Questions/Answers

Solicitation 36C26323R00001

Upgrade Mental Health Lock Ward

Date: October 25, 2022	Project: VA FM Upgrade Mental Health Lock Ward
To: Stone Group Architects	Project #: VAMC 68-20-102 WPE: BR21045
From: West Plains Engineering 1750 Rand Road Rapid City, SD 57702	Project Location: Ft. Meade, SD Addendum #: Addendum 0001

4 WALL SECTION @ NEW WINDOW
148-2|148-8 SCALE: 1" = 1'-0"

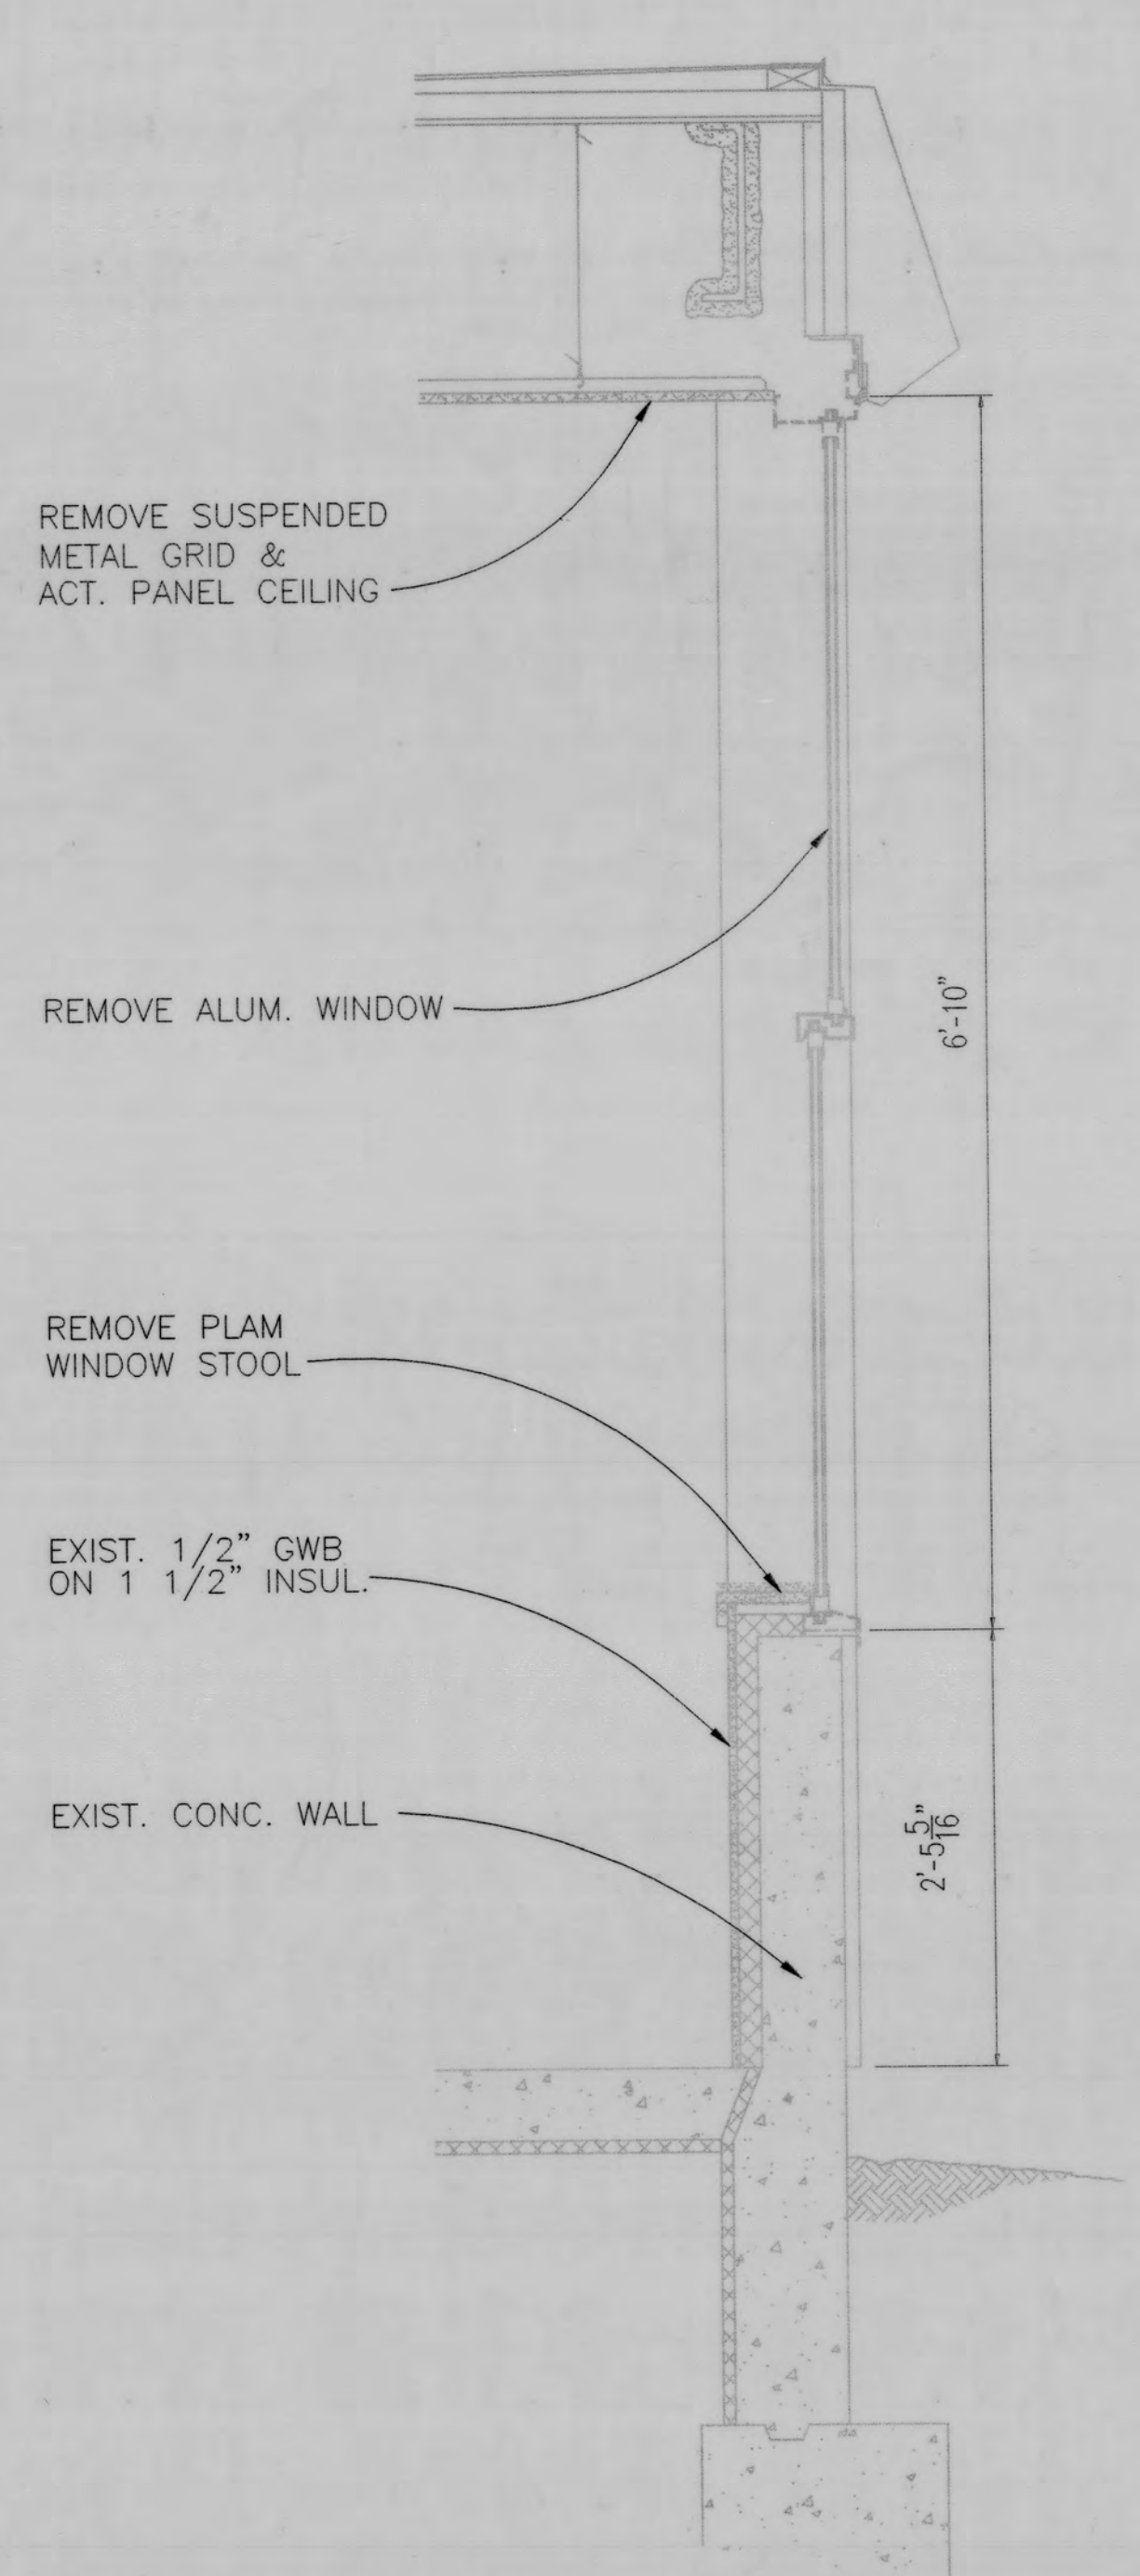
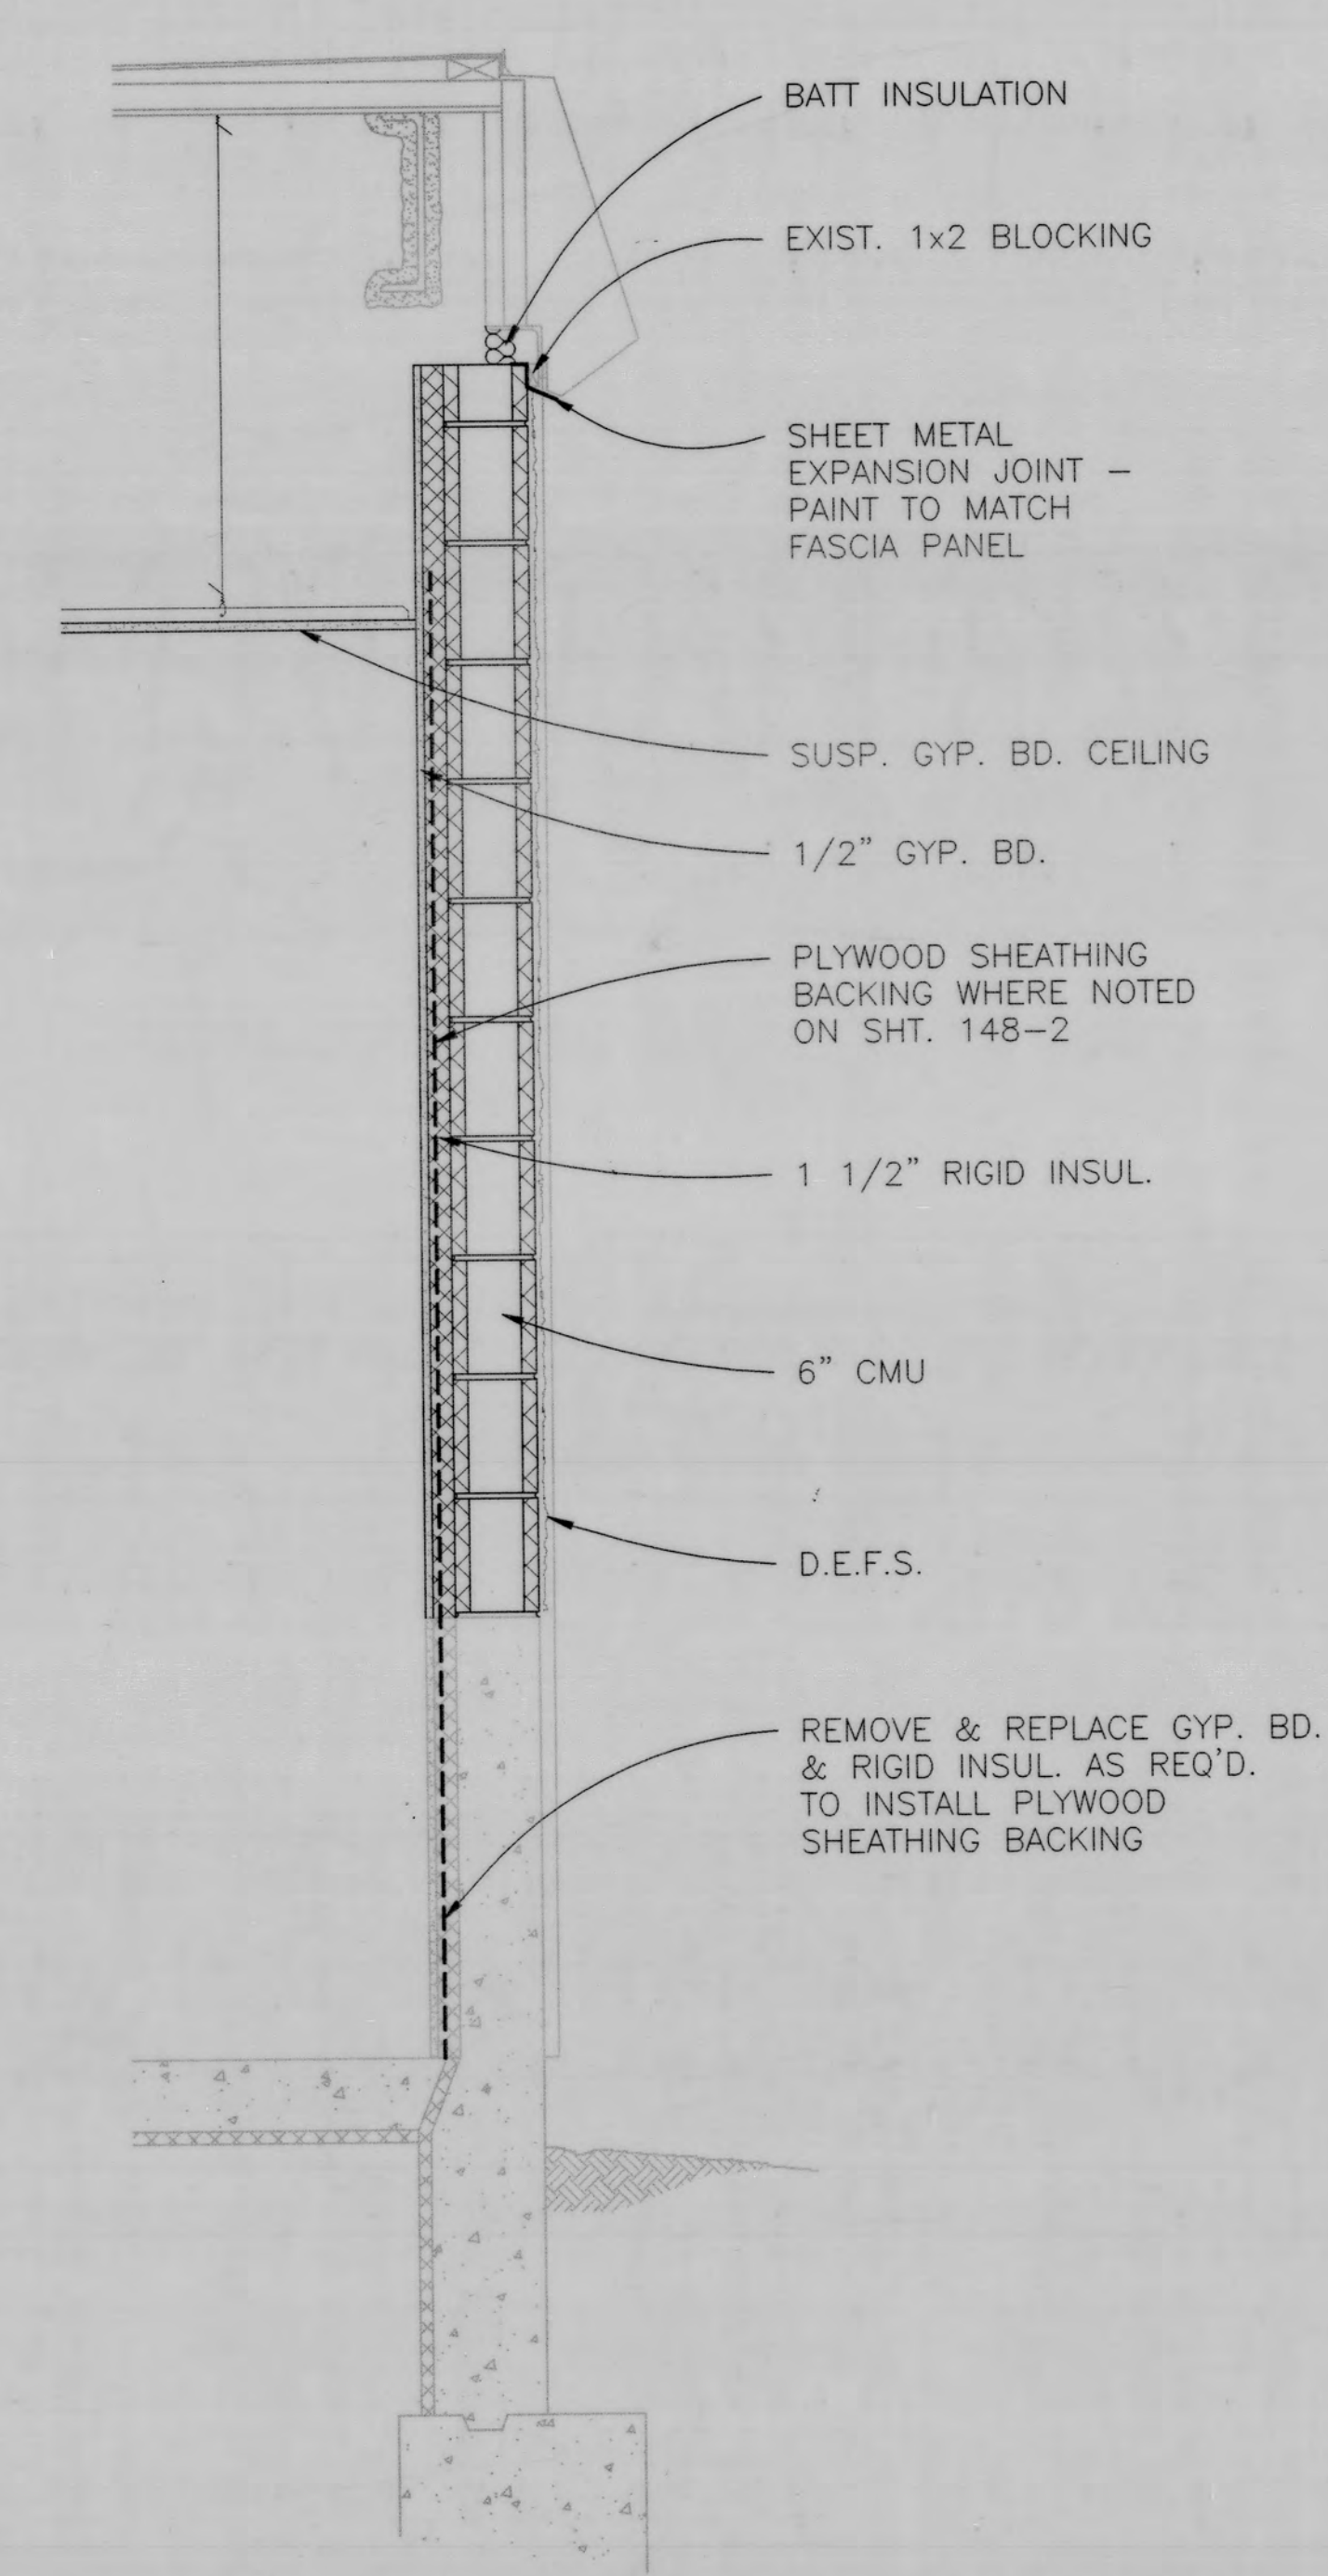
7	DIV 12 Please confirm the specs 12 36 00 are referring to window sills and not countertops. Please confirm what window types are to receive window sills. Please confirm Material, Colors, and edging.	AE: Yes, Division 12 is included for solid surface window sills. Windows getting sills are noted by keynote 6.60C on Sheet AE-101.
8	Period of Performance Does the PoP account for long lead times certain Divisions have when procuring material/equipment?	No - we have run into this issue on several of our contracts. If you feel that there are several long lead items, we can provide a limited NTP at the Pre-Construction meeting. When the submittals are approved and the items are expected, we can issue the Notice to proceed.
9	DIV 8 Please confirm that the only new storefront windows will be the (3) type C2 windows.	AE: yes the only fully new aluminum windows are the ones noted C2.
10	DIV 8 Per glass manufacturer the type D, D2, and D6 door lites are too small to be tempered laminated glass. They can be annealed lami but not tempered lami. Please advise	AE: we confirmed with a manufacturer that the size of the glass is not available as tempered laminated. Please provided annealed laminated glass for these lite only.
